New 4 Story Medical Office Building V... see #07-00... for foundation only

AT 50 ST JOHN ST

2/27/2007-ldobson: I have completed the IBC compliance review and will need the following clarifications/or additional information. I've discovered that the permit still needs final City Fire and Zoning sign-offs, so I'll be bringing it to City Hall first thing on Monday to get that taken care of. Hopefully, timing wise, they will be done with it quickly and the additional information that I request today will come back to me at the same time, allowing final clean sign off. My review is done so this is the final list:

Subject: Landmark – Fore River Medical Pavillon
Portland, Maine
Response to Plan Review Email

BASIS OF DESIGN - AUTO SLIDING ENTRANCE DOOR (SECTION 08460)

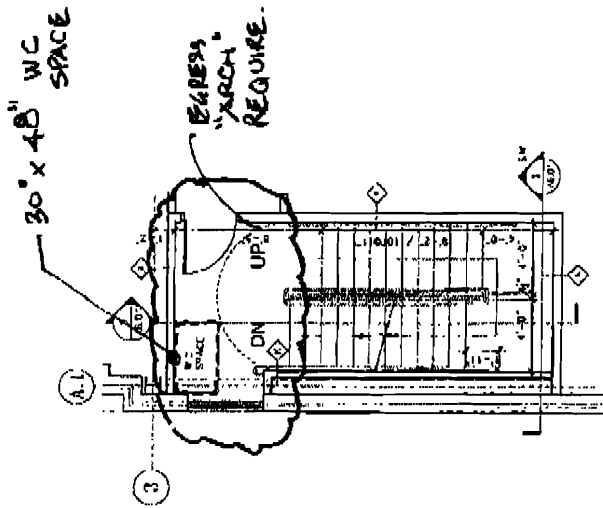
6) Please confirm that the horizontal sliding doors will comply with all elements of Section 1008.1.3.3 of the 2003 IBC.

Response: Power Operated (Sliding Entrance) Doors have break away swing leaves and comply with Section 1008.1.3.2 Power Operated Doors & 1008.1.3.3 Horizontal sliding doors. See attachment – Basis of Design product Data.

STAIR PLAN ATTACHMENT

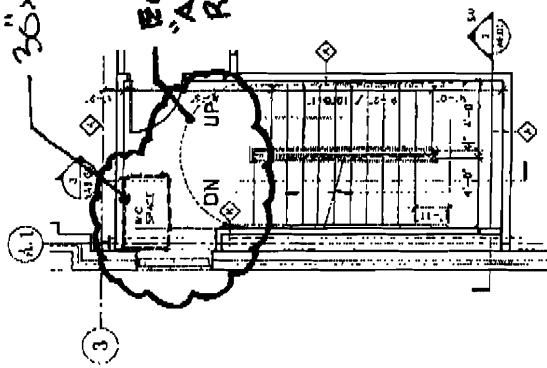
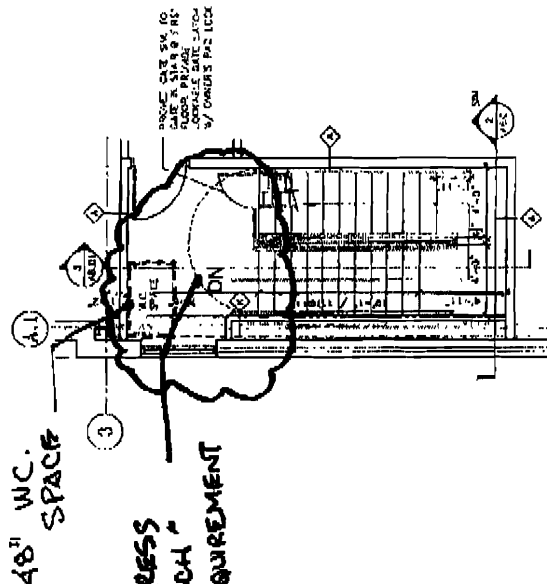
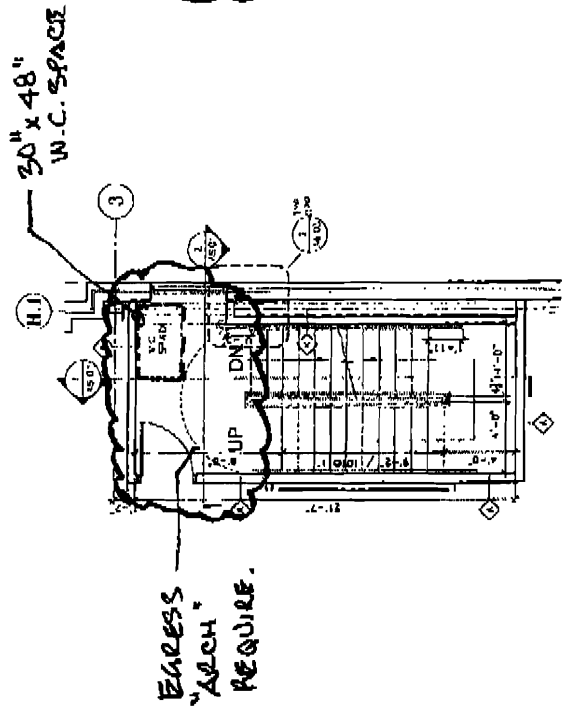
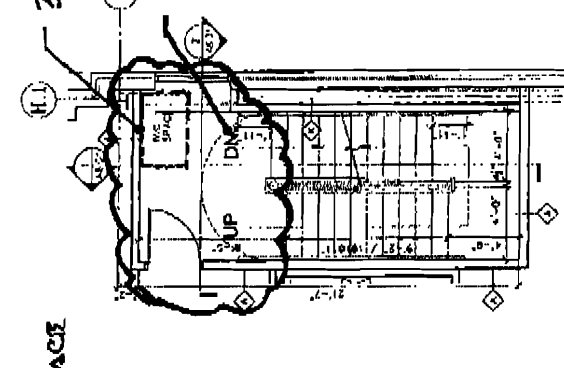
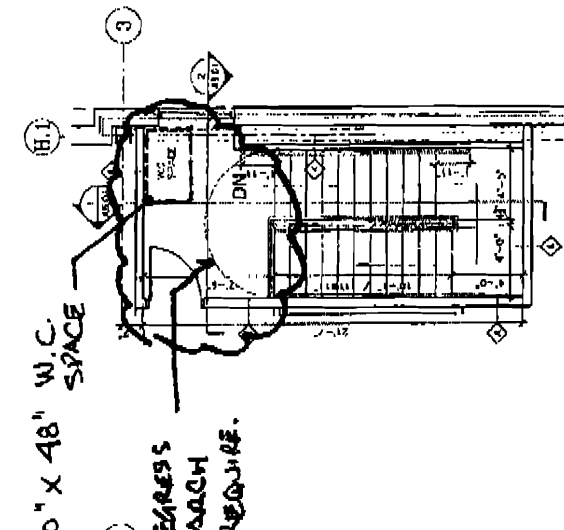
5) Please provide a compliance summary for section 1007.6; Area of Refuge.

Response: One wheel chair space (30" x 48") is located at the 2nd, 3rd & 4th Floor Landings in Stairs "A" & "B" that is clear of the exit egress path (arch) of the stairs. First Floor "Area of Refuge" will be handled within the one hour fire rated Atrium. See stair plan attachment.

BASIS OF DESIGN - ALT. TREAD DEVICE

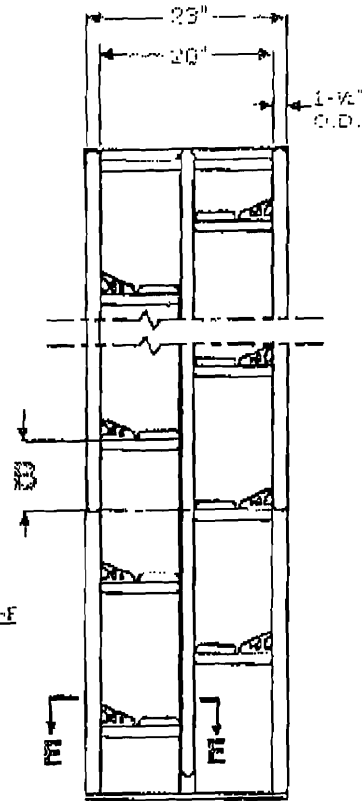
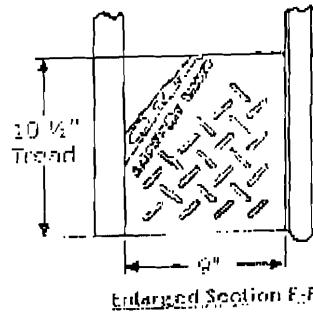
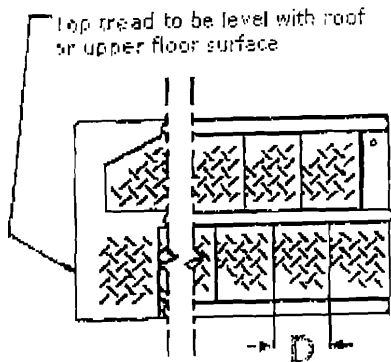
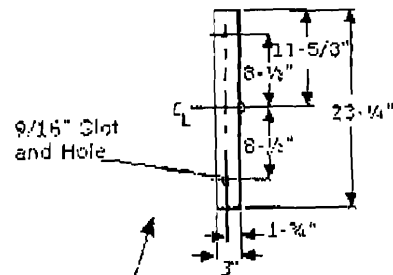
7) Please confirm that the Alternating Tread Device will comply with all elements of Section 1009.10 of the 2003 IBC. (HANDRAILS!!!!)

Response: The Alternating Tread Device complies with Section 1009.10 & 1009.11 – Handrails. The project's Alternating Tread Devices has handrails on each side. See Basis of Design – Product Information.
